**Flood Control Project Maintenance
Levee Inspections**
LMA District Cover Sheet
Spring 2018 Levee Inspection Results

Reclamation District No. 0556 Upper Andrus

Levee Inspection Report By Mile - Spring 2018

Waterway	Bank	Unit Miles	Inspection Start/End	Inspector
Unit No. 01 Georgiana Slough	Right	5.48	04/05/2018 04/05/2018	Keith Millard

Photo 1 of 1 : SP_2018_RD0556_18_24_20180305_00007.jpg

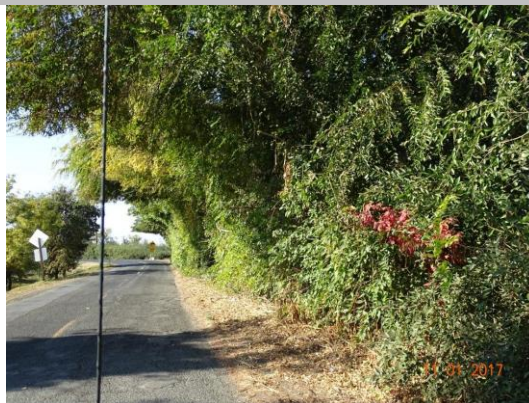
LM Start	0.87	Rating **	U	Issue No.	24
LM End	0.92	Issue Type +	En	Location *	LS
Category	Earthen Levee			GPS Latitude/Longitude	
				Start	End
Item	Vegetation			38.228820 °	38.228480 °
				-121.525853 °	-121.526470 °
DWR ID	DWR_RD0556_01_f_2017_24				
Comment Code					
V6 : Landscaping					
Inspector Comment

Trim/thin landscaping to allow inspection and access to levee slope and toe.

Photo 1 of 2 : SP_2018_RD0556_18_31_20180305_00016.jpg

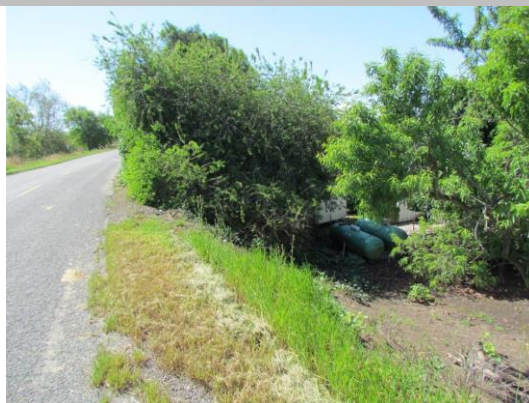
LM Start	2.38	Rating **	U	Issue No.	31
LM End	2.43	Issue Type +	En	Location *	LS
Category	Earthen Levee			GPS Latitude/Longitude	
				Start	End
Item	Vegetation			38.219037 °	38.218342 °
				-121.543847 °	-121.543842 °
DWR ID	DWR_RD0556_01_s_2017_31				
Comment Code					
V6 : Landscaping					
Inspector Comment

Looking downstream from the landside shoulder woody tree growth blocking the slope and shoulder.

Photo 1 of 1 : SP_2018_RD0556_19_25_20180305_00010.jpg

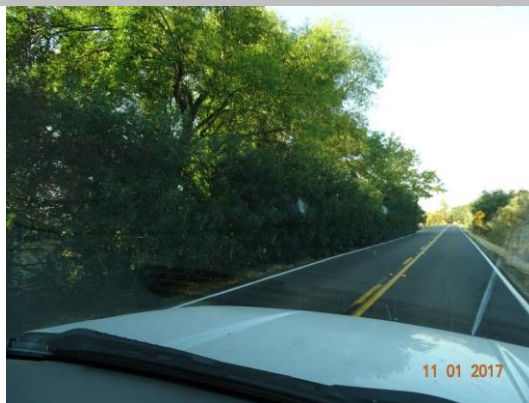
LM Start	0.55	Rating **	M	Issue No.	25
LM End	0.55	Issue Type +	En	Location *	LS
Category	Earthen Levee			GPS Latitude/Longitude	
				Start	End
Item	Vegetation			38.237810 °	38.237810 °
				-121.528182 °	-121.528182 °
DWR ID	DWR_RD0556_02_f_2017_25				
Comment Code					
V6 : Landscaping					
Inspector Comment

Trim/thin oleanders.

Photo 3 of 3 : UCIP_SP_2018_41713_20282.jpg

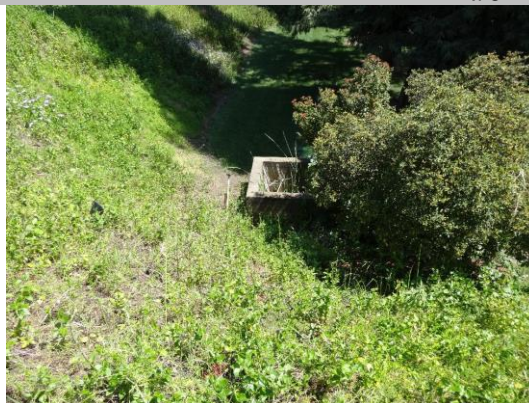
Comment Code						
Inspector Comment						
FS_ID:41713 DS_ID:20849 EP_NO: 11181 Repair Type: Non-Urgent Crossing Status: Found UCIP Comments: - Needs to clean siphon breaker CMP riser. FIELD_STRUCT_DESC: 6-inch irrigation discharge pipe of an unknown material through the levee, 6 feet below the crown. Pressure tank in a pump house on the waterside (WS) berm. Service pole, siphon breaker, and distribution box on the landside (LS) slope. (Retention of a 6-inch pipe through the levee, 6 feet below the crown; a pump, a gate valve, and a pressure tank on the WS berm; and a service pole on the LS slope authorized under Automatic Board Order (ABO) issued as Permit No. 11181, 1975 - Robert E. and G. P. Collins). [Additional Reference(s): DWR Levee Log]. FS Date: 4/25/2013

LS- concrete distribution box near toe of the levee

Photo 1 of 1 : SP_2018_RD0556_19_8_20180305_00007.jpg

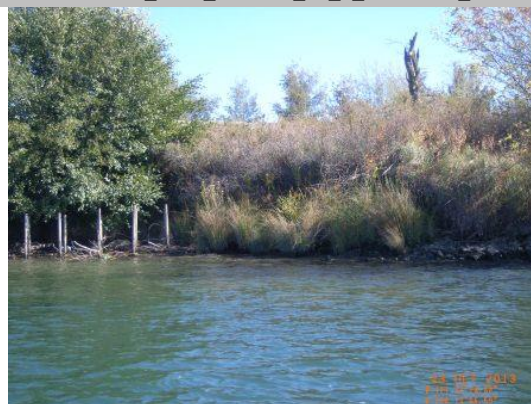
LM Start	3.58	Rating **	M	Issue No.	8
LM End	3.64	Issue Type +	Ma	Location *	WS
Category	Supplemental		GPS Latitude/Longitude		
			Start	End	
Item	2015 USACE Erosion Survey, DRAFT		38.218951 °	38.218104 °	
			-121.556689 °	-121.556819 °	
DWR ID	DWR_RD0556_02_f_2016_8				
Comment Code					
Inspector Comment					
1997 - Scallops into berm and very close to levee toe. 2005 - Brush boxes present. 2011 - New toe scour and freshly fallen tree. 2012 - New tree popout has taken significant portion of soil out of the levee. 2015: No observed changes. [2015 Site ID: SAC_22-7_L]

Photo 1 of 1 : SP_2018_RD0556_19_37_20180305_00022.jpg

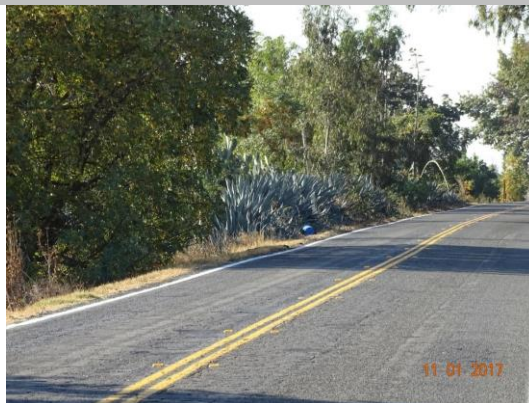
LM Start	5.08	Rating **	U	Issue No.	37
LM End	5.16	Issue Type +	En	Location *	LS
Category	Earthen Levee			GPS Latitude/Longitude	
				Start	End
Item	Vegetation			38.197407 °	38.196378 °
				-121.558950 °	-121.559601 °
DWR ID	DWR_RD0556_02_f_2017_37				
Comment Code					
V6 : Landscaping					
Inspector Comment

Remove large cactus to allow inspection and access to landside slope and toe.
